**Irish Water**

**Greater Dublin Drainage**

**Brief of Evidence**

**Regional Biosolids Storage Facility**

Diagram 4-4

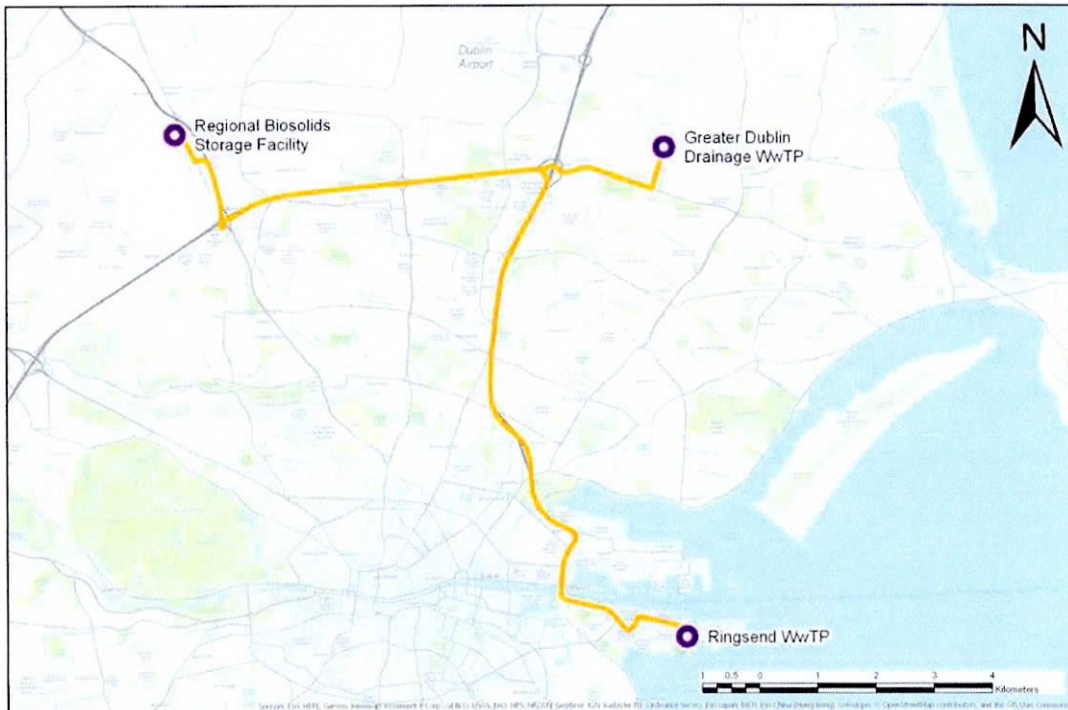
- 8 The location selected for the proposed RBSF is at a site in Newtown, Dublin 11. I refer to Diagram 4-4 in Section 4 of Volume 2 of the EIAR, which shows the site located to the west of Dublin Airport and north of the M50. The transport routes to the proposed RBSF from the proposed WwTP and Ringsend WwTP are shown in yellow. The travel distance from the proposed WwTP is 9 km and from Ringsend WwTP it is 18 km.

**Diagram 4-6**

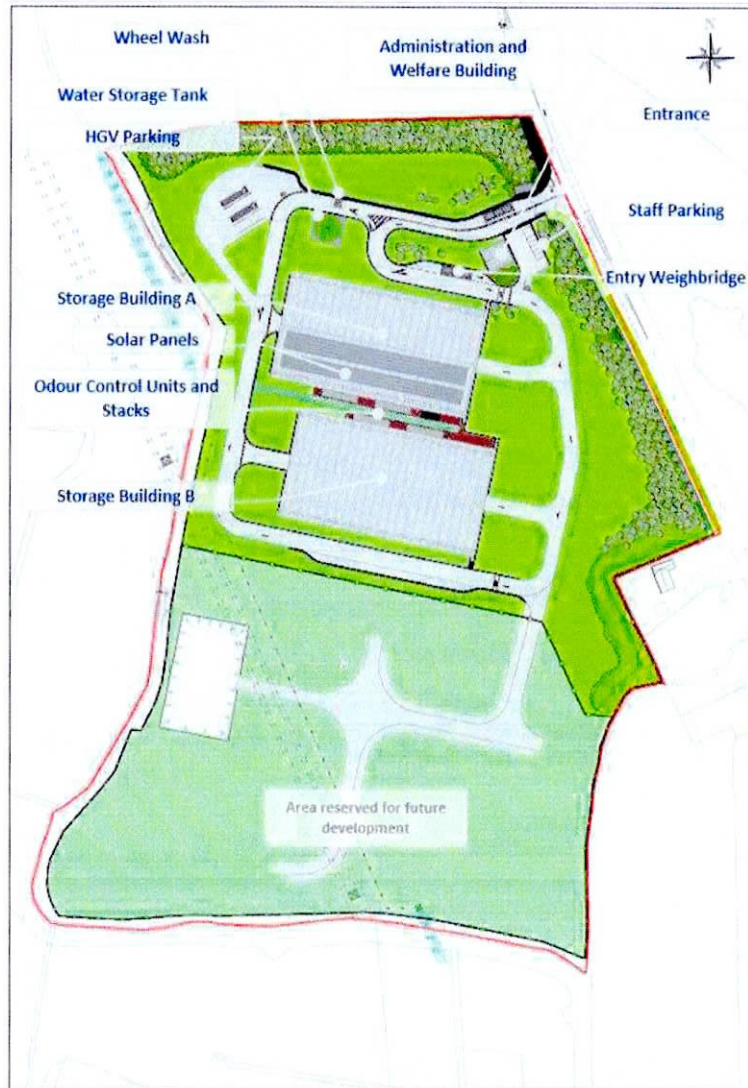
- 9 The site was identified through a selection process that took place in 2017 and involved a three-stage non-statutory public consultation process. The site comprises approximately 11 hectares of partially-developed land and is situated off the R135 road, on the western side of the N2 national road. Diagram 4-5 in Section 4 of Volume 2 Part A of the EIAR shows the existing site. Diagram 4-6 shows the proposed layout of the RBSF, which generally comprises two storage buildings in the central area of the site and internal circulation roads around both buildings.
